CWM CHEMICAL SERVICES, LLC

December 2, 2013

Re: SPDES Permit #NY0072061 Modification Request

MONITORING LOCATIONS

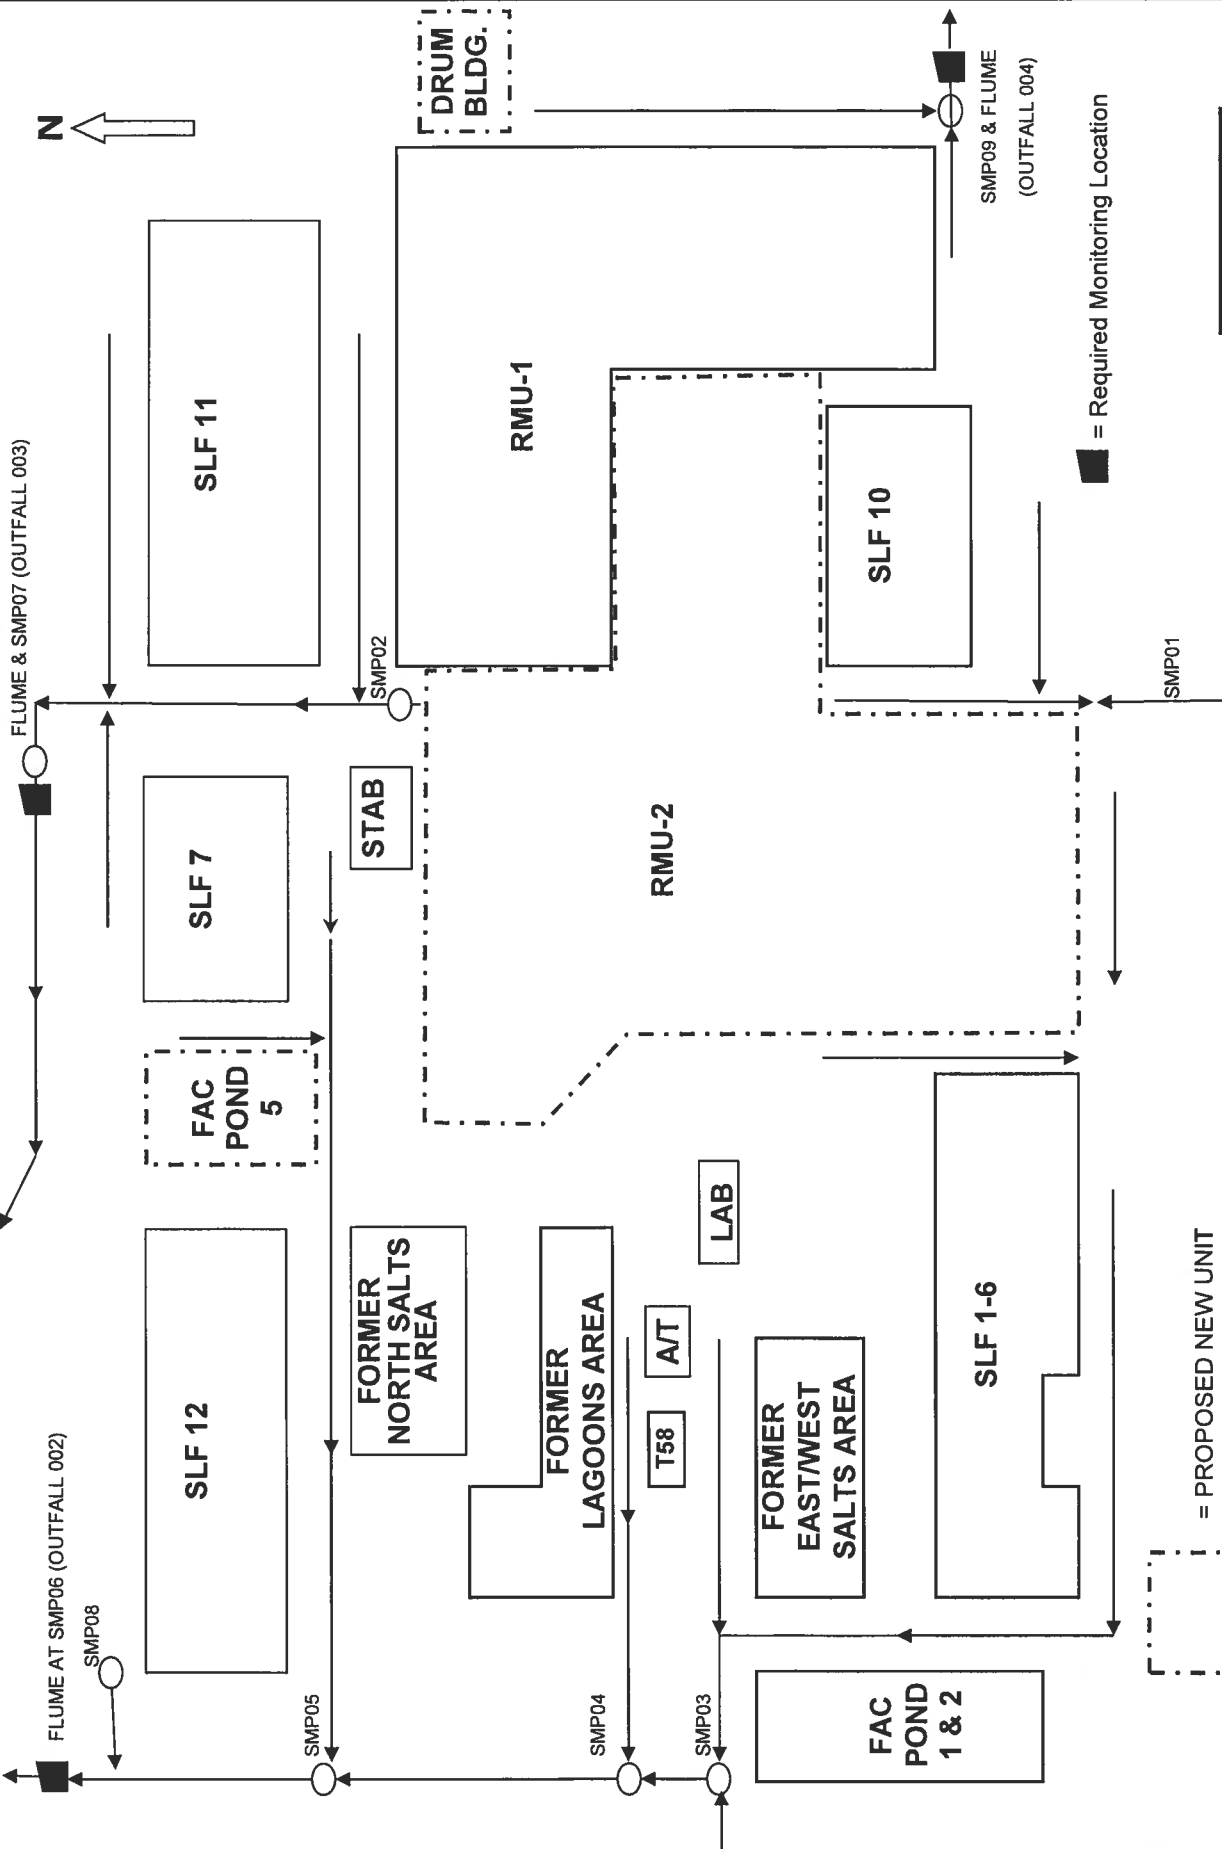
** = Fac Pond 3 will be closed and replaced with Fac Pond 5 for construction of RMU-2

○ = Potential alternate Monitoring Location during closure of Fac Pond 3

*** = Discharge to Outfall 001 may occur from Fac Pond 1 & 2 during closure of Fac Pond 3

Note: Site Conditions upon construction of RMU-2, Fac Pond 5, and New Drum Building
